Design Review Board

McDonald's – 517 W 3rd Ave

Design Review Staff Report

RE: Planning NREC Design Review for **MCDONALD'S REMODEL**
517 W Third Ave
Spokane, WA
PMDG JOB NO. MCD17235

Figure 1. Typical planter bed expansion

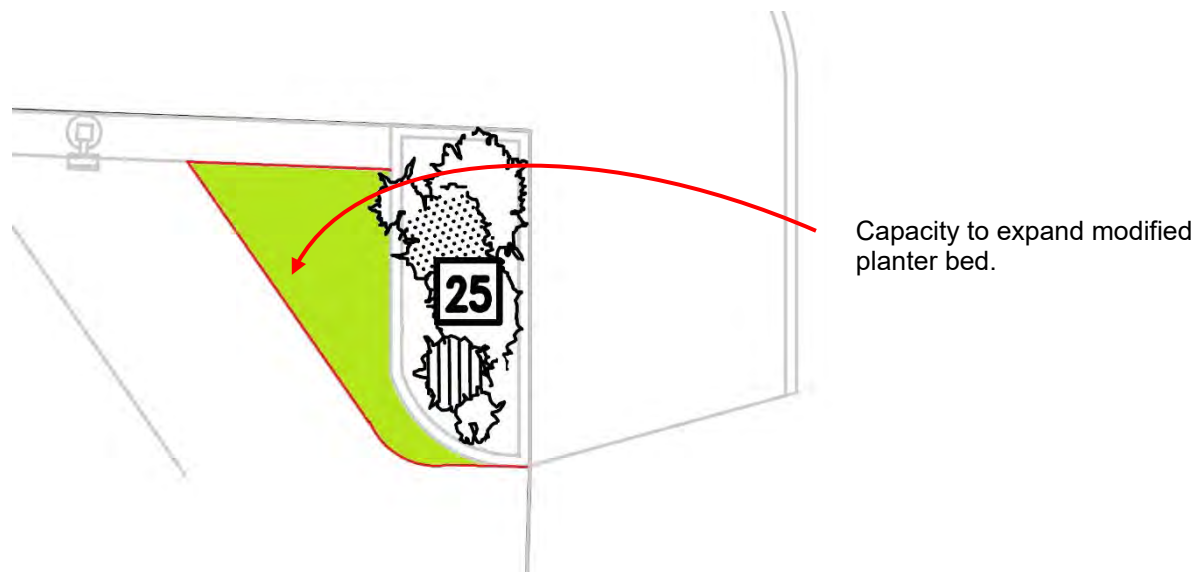
One additional item for consideration rests with the corner landscaping beds at the site's vehicle ingress/egress lanes onto 3rd Avenue. The adjacent parking stalls are diagonally striped, and with the removal of the raised planter beds there is an opportunity to increase the square footage of the beds without impacting the parking stalls or their count (see Figure 1).

PROPOSED SITE PLAN SCALE: 1"=15'-0"

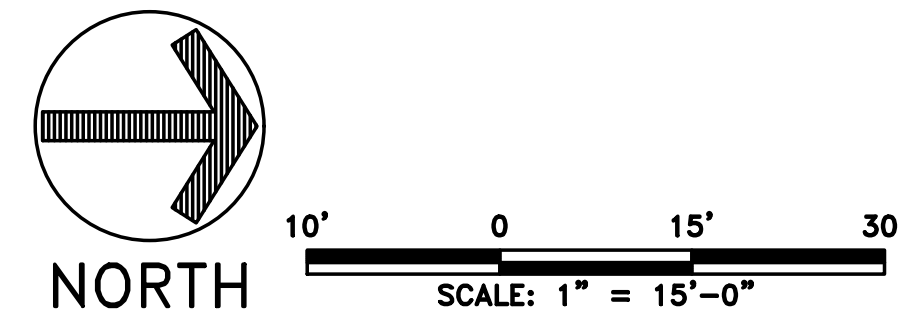
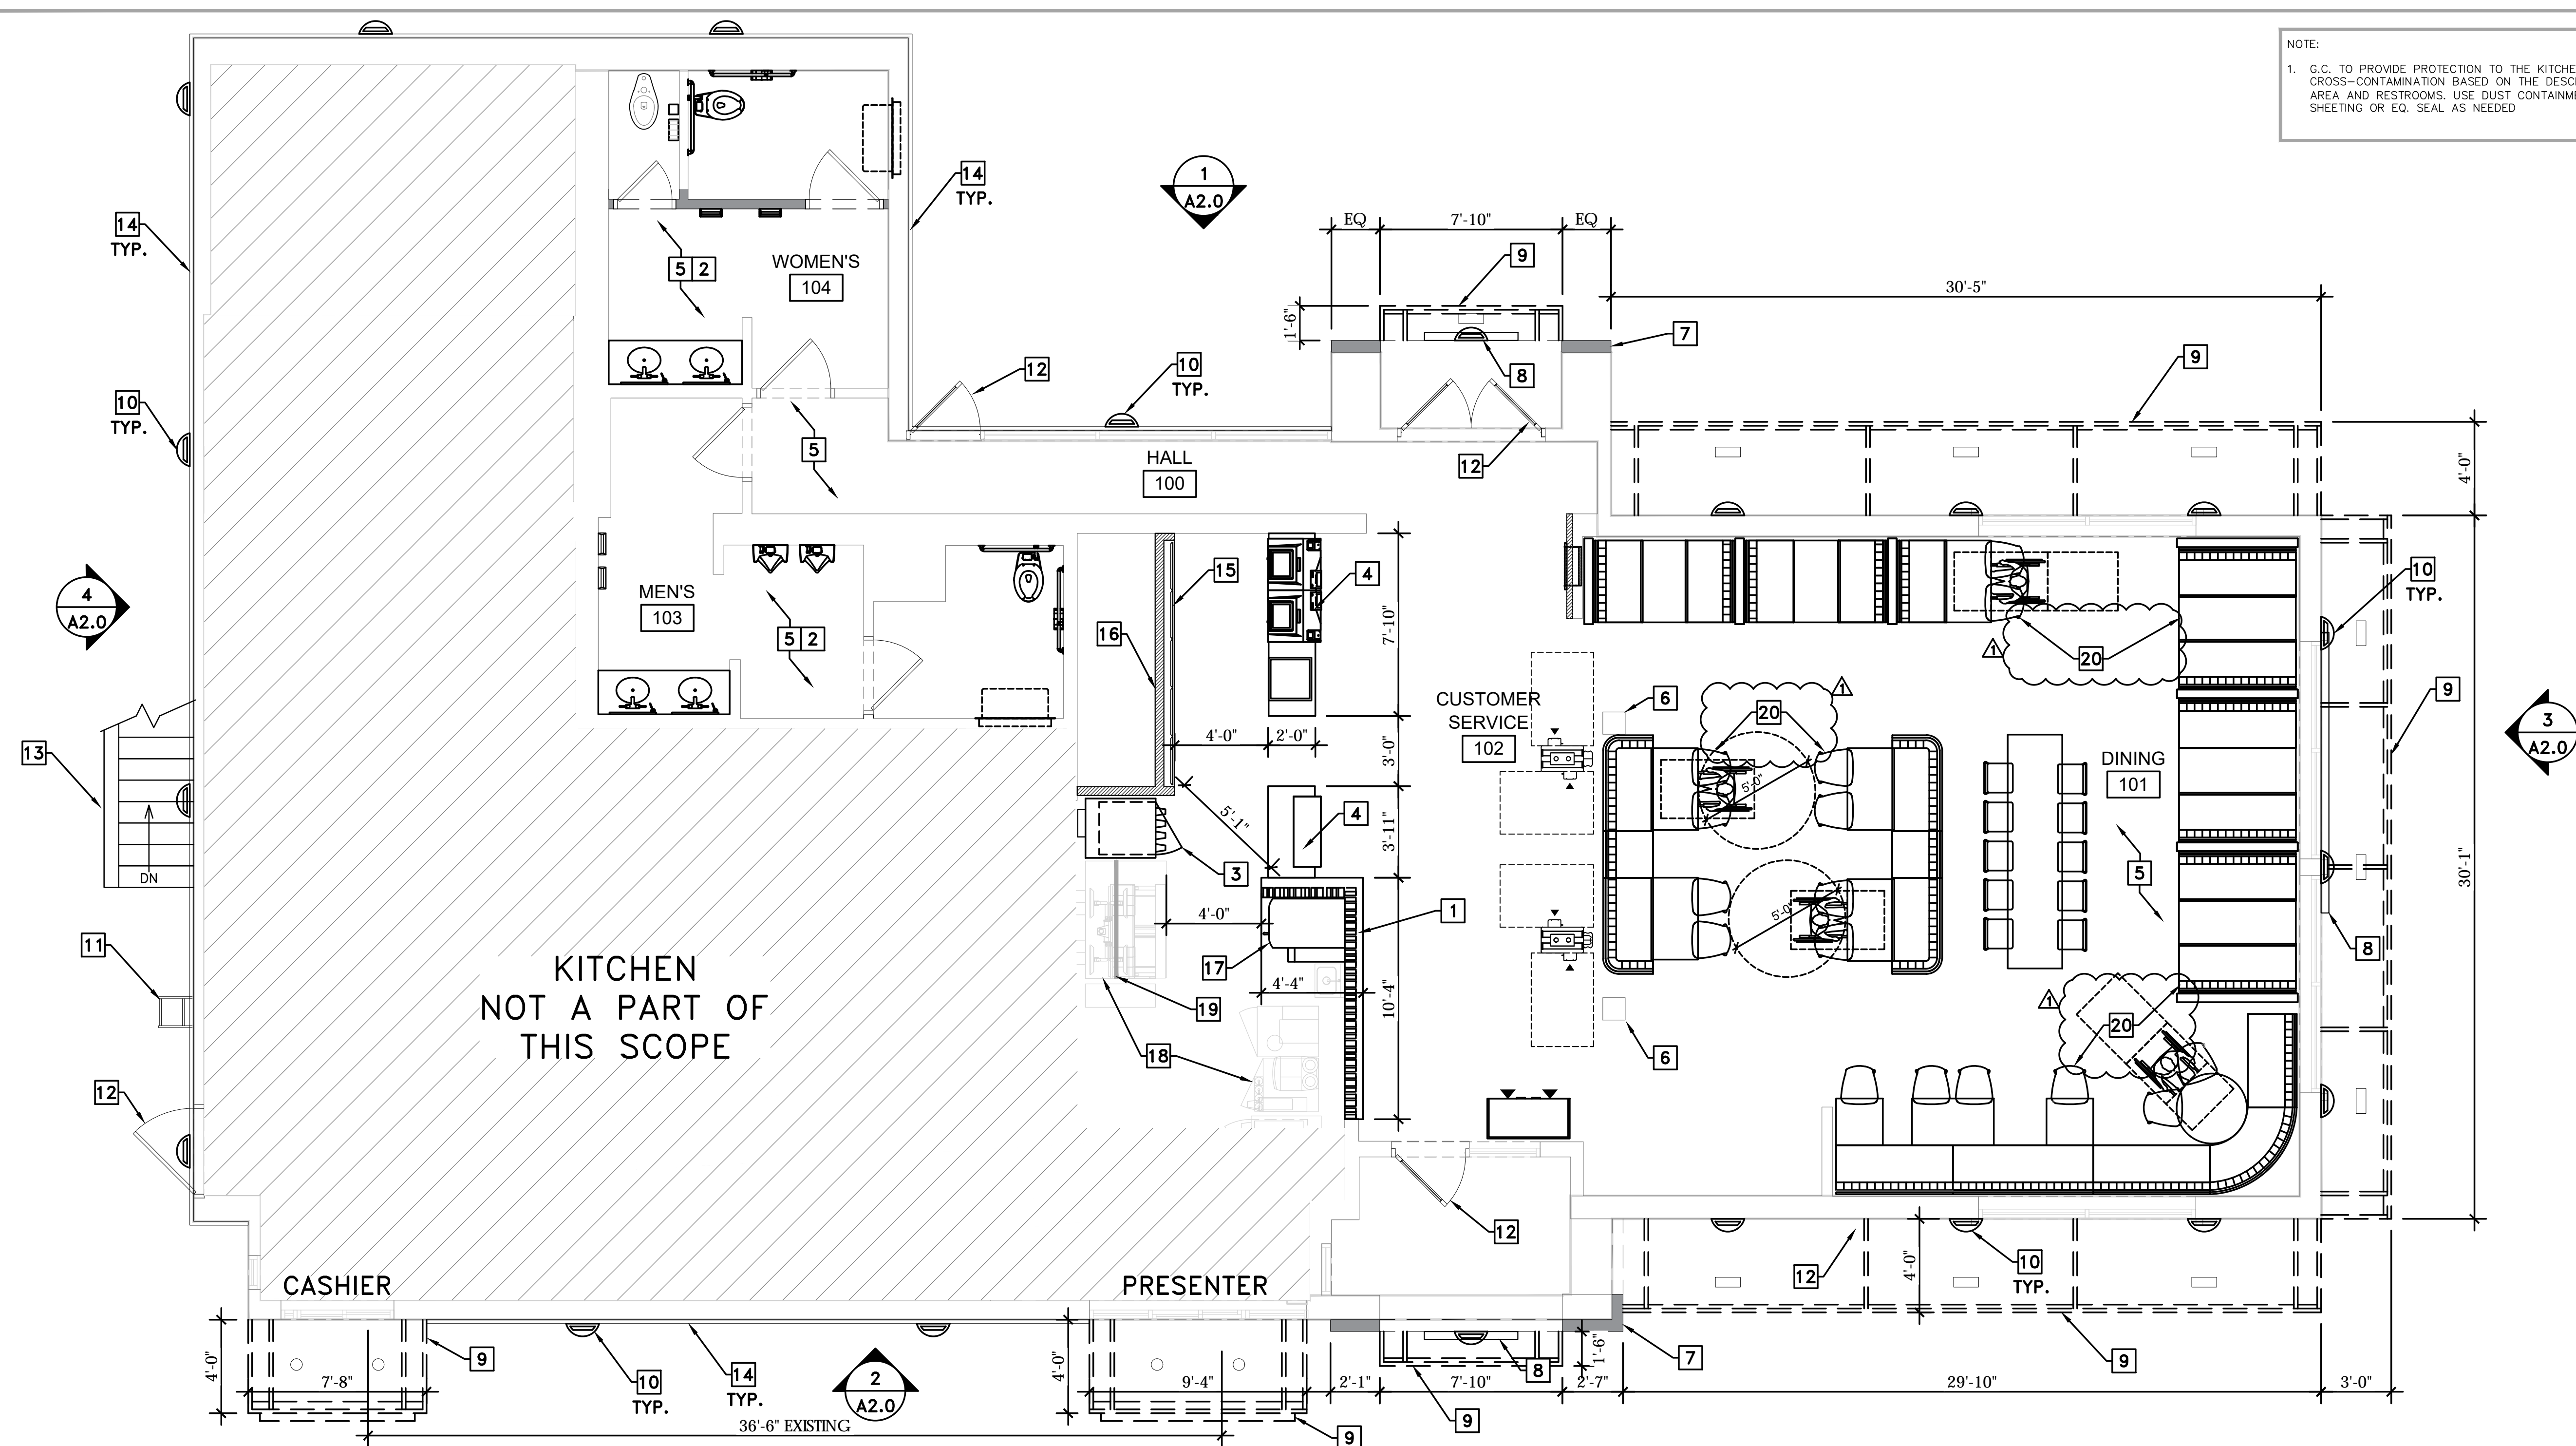
1. The applicant shall consider landscape improvements along the Howard Street frontage to include street trees and landscape buffer (which may be located along the back of sidewalk).

2. The applicant shall consider the introduction of an accessible path connecting the Howard Street sidewalk to the site's accessible route to the primary entrance.

3. The applicant shall consider the removal of the raised/masonry planters throughout the site and replace with plantings at grade (where possible). Additionally, the plant palette should consider CPTED principles.

7. The applicant shall investigate the incorporation of the site furnishings identified in the City of Spokane Streetscape Improvement Plan (SIP) – specific to the Freeway District 3 standards.

The Applicant has added landscape improvements to Howard Street including street trees with 4'x8' grates and metal tree guards per Section 17 of the Municipal Code/SIP and revised planting areas.

Applicant has introduced an accessible path at the Howard Street sidewalk by cutting through McDonald's existing concrete curb at the proposed ADA parking location. This creates a direct connection leading from Howard Street to the main store entry via the new accessible striped crosswalk.

The Applicant has shown all existing raised/masonry planters as being removed throughout the site. Plantings shall be at grade and take into account CPTED principles.

The Applicant has investigated the incorporation of site furnishings, taking into account District 3 standards, and has included the proposed trash containers, bike rack and tree grates throughout the site and adjacent street.
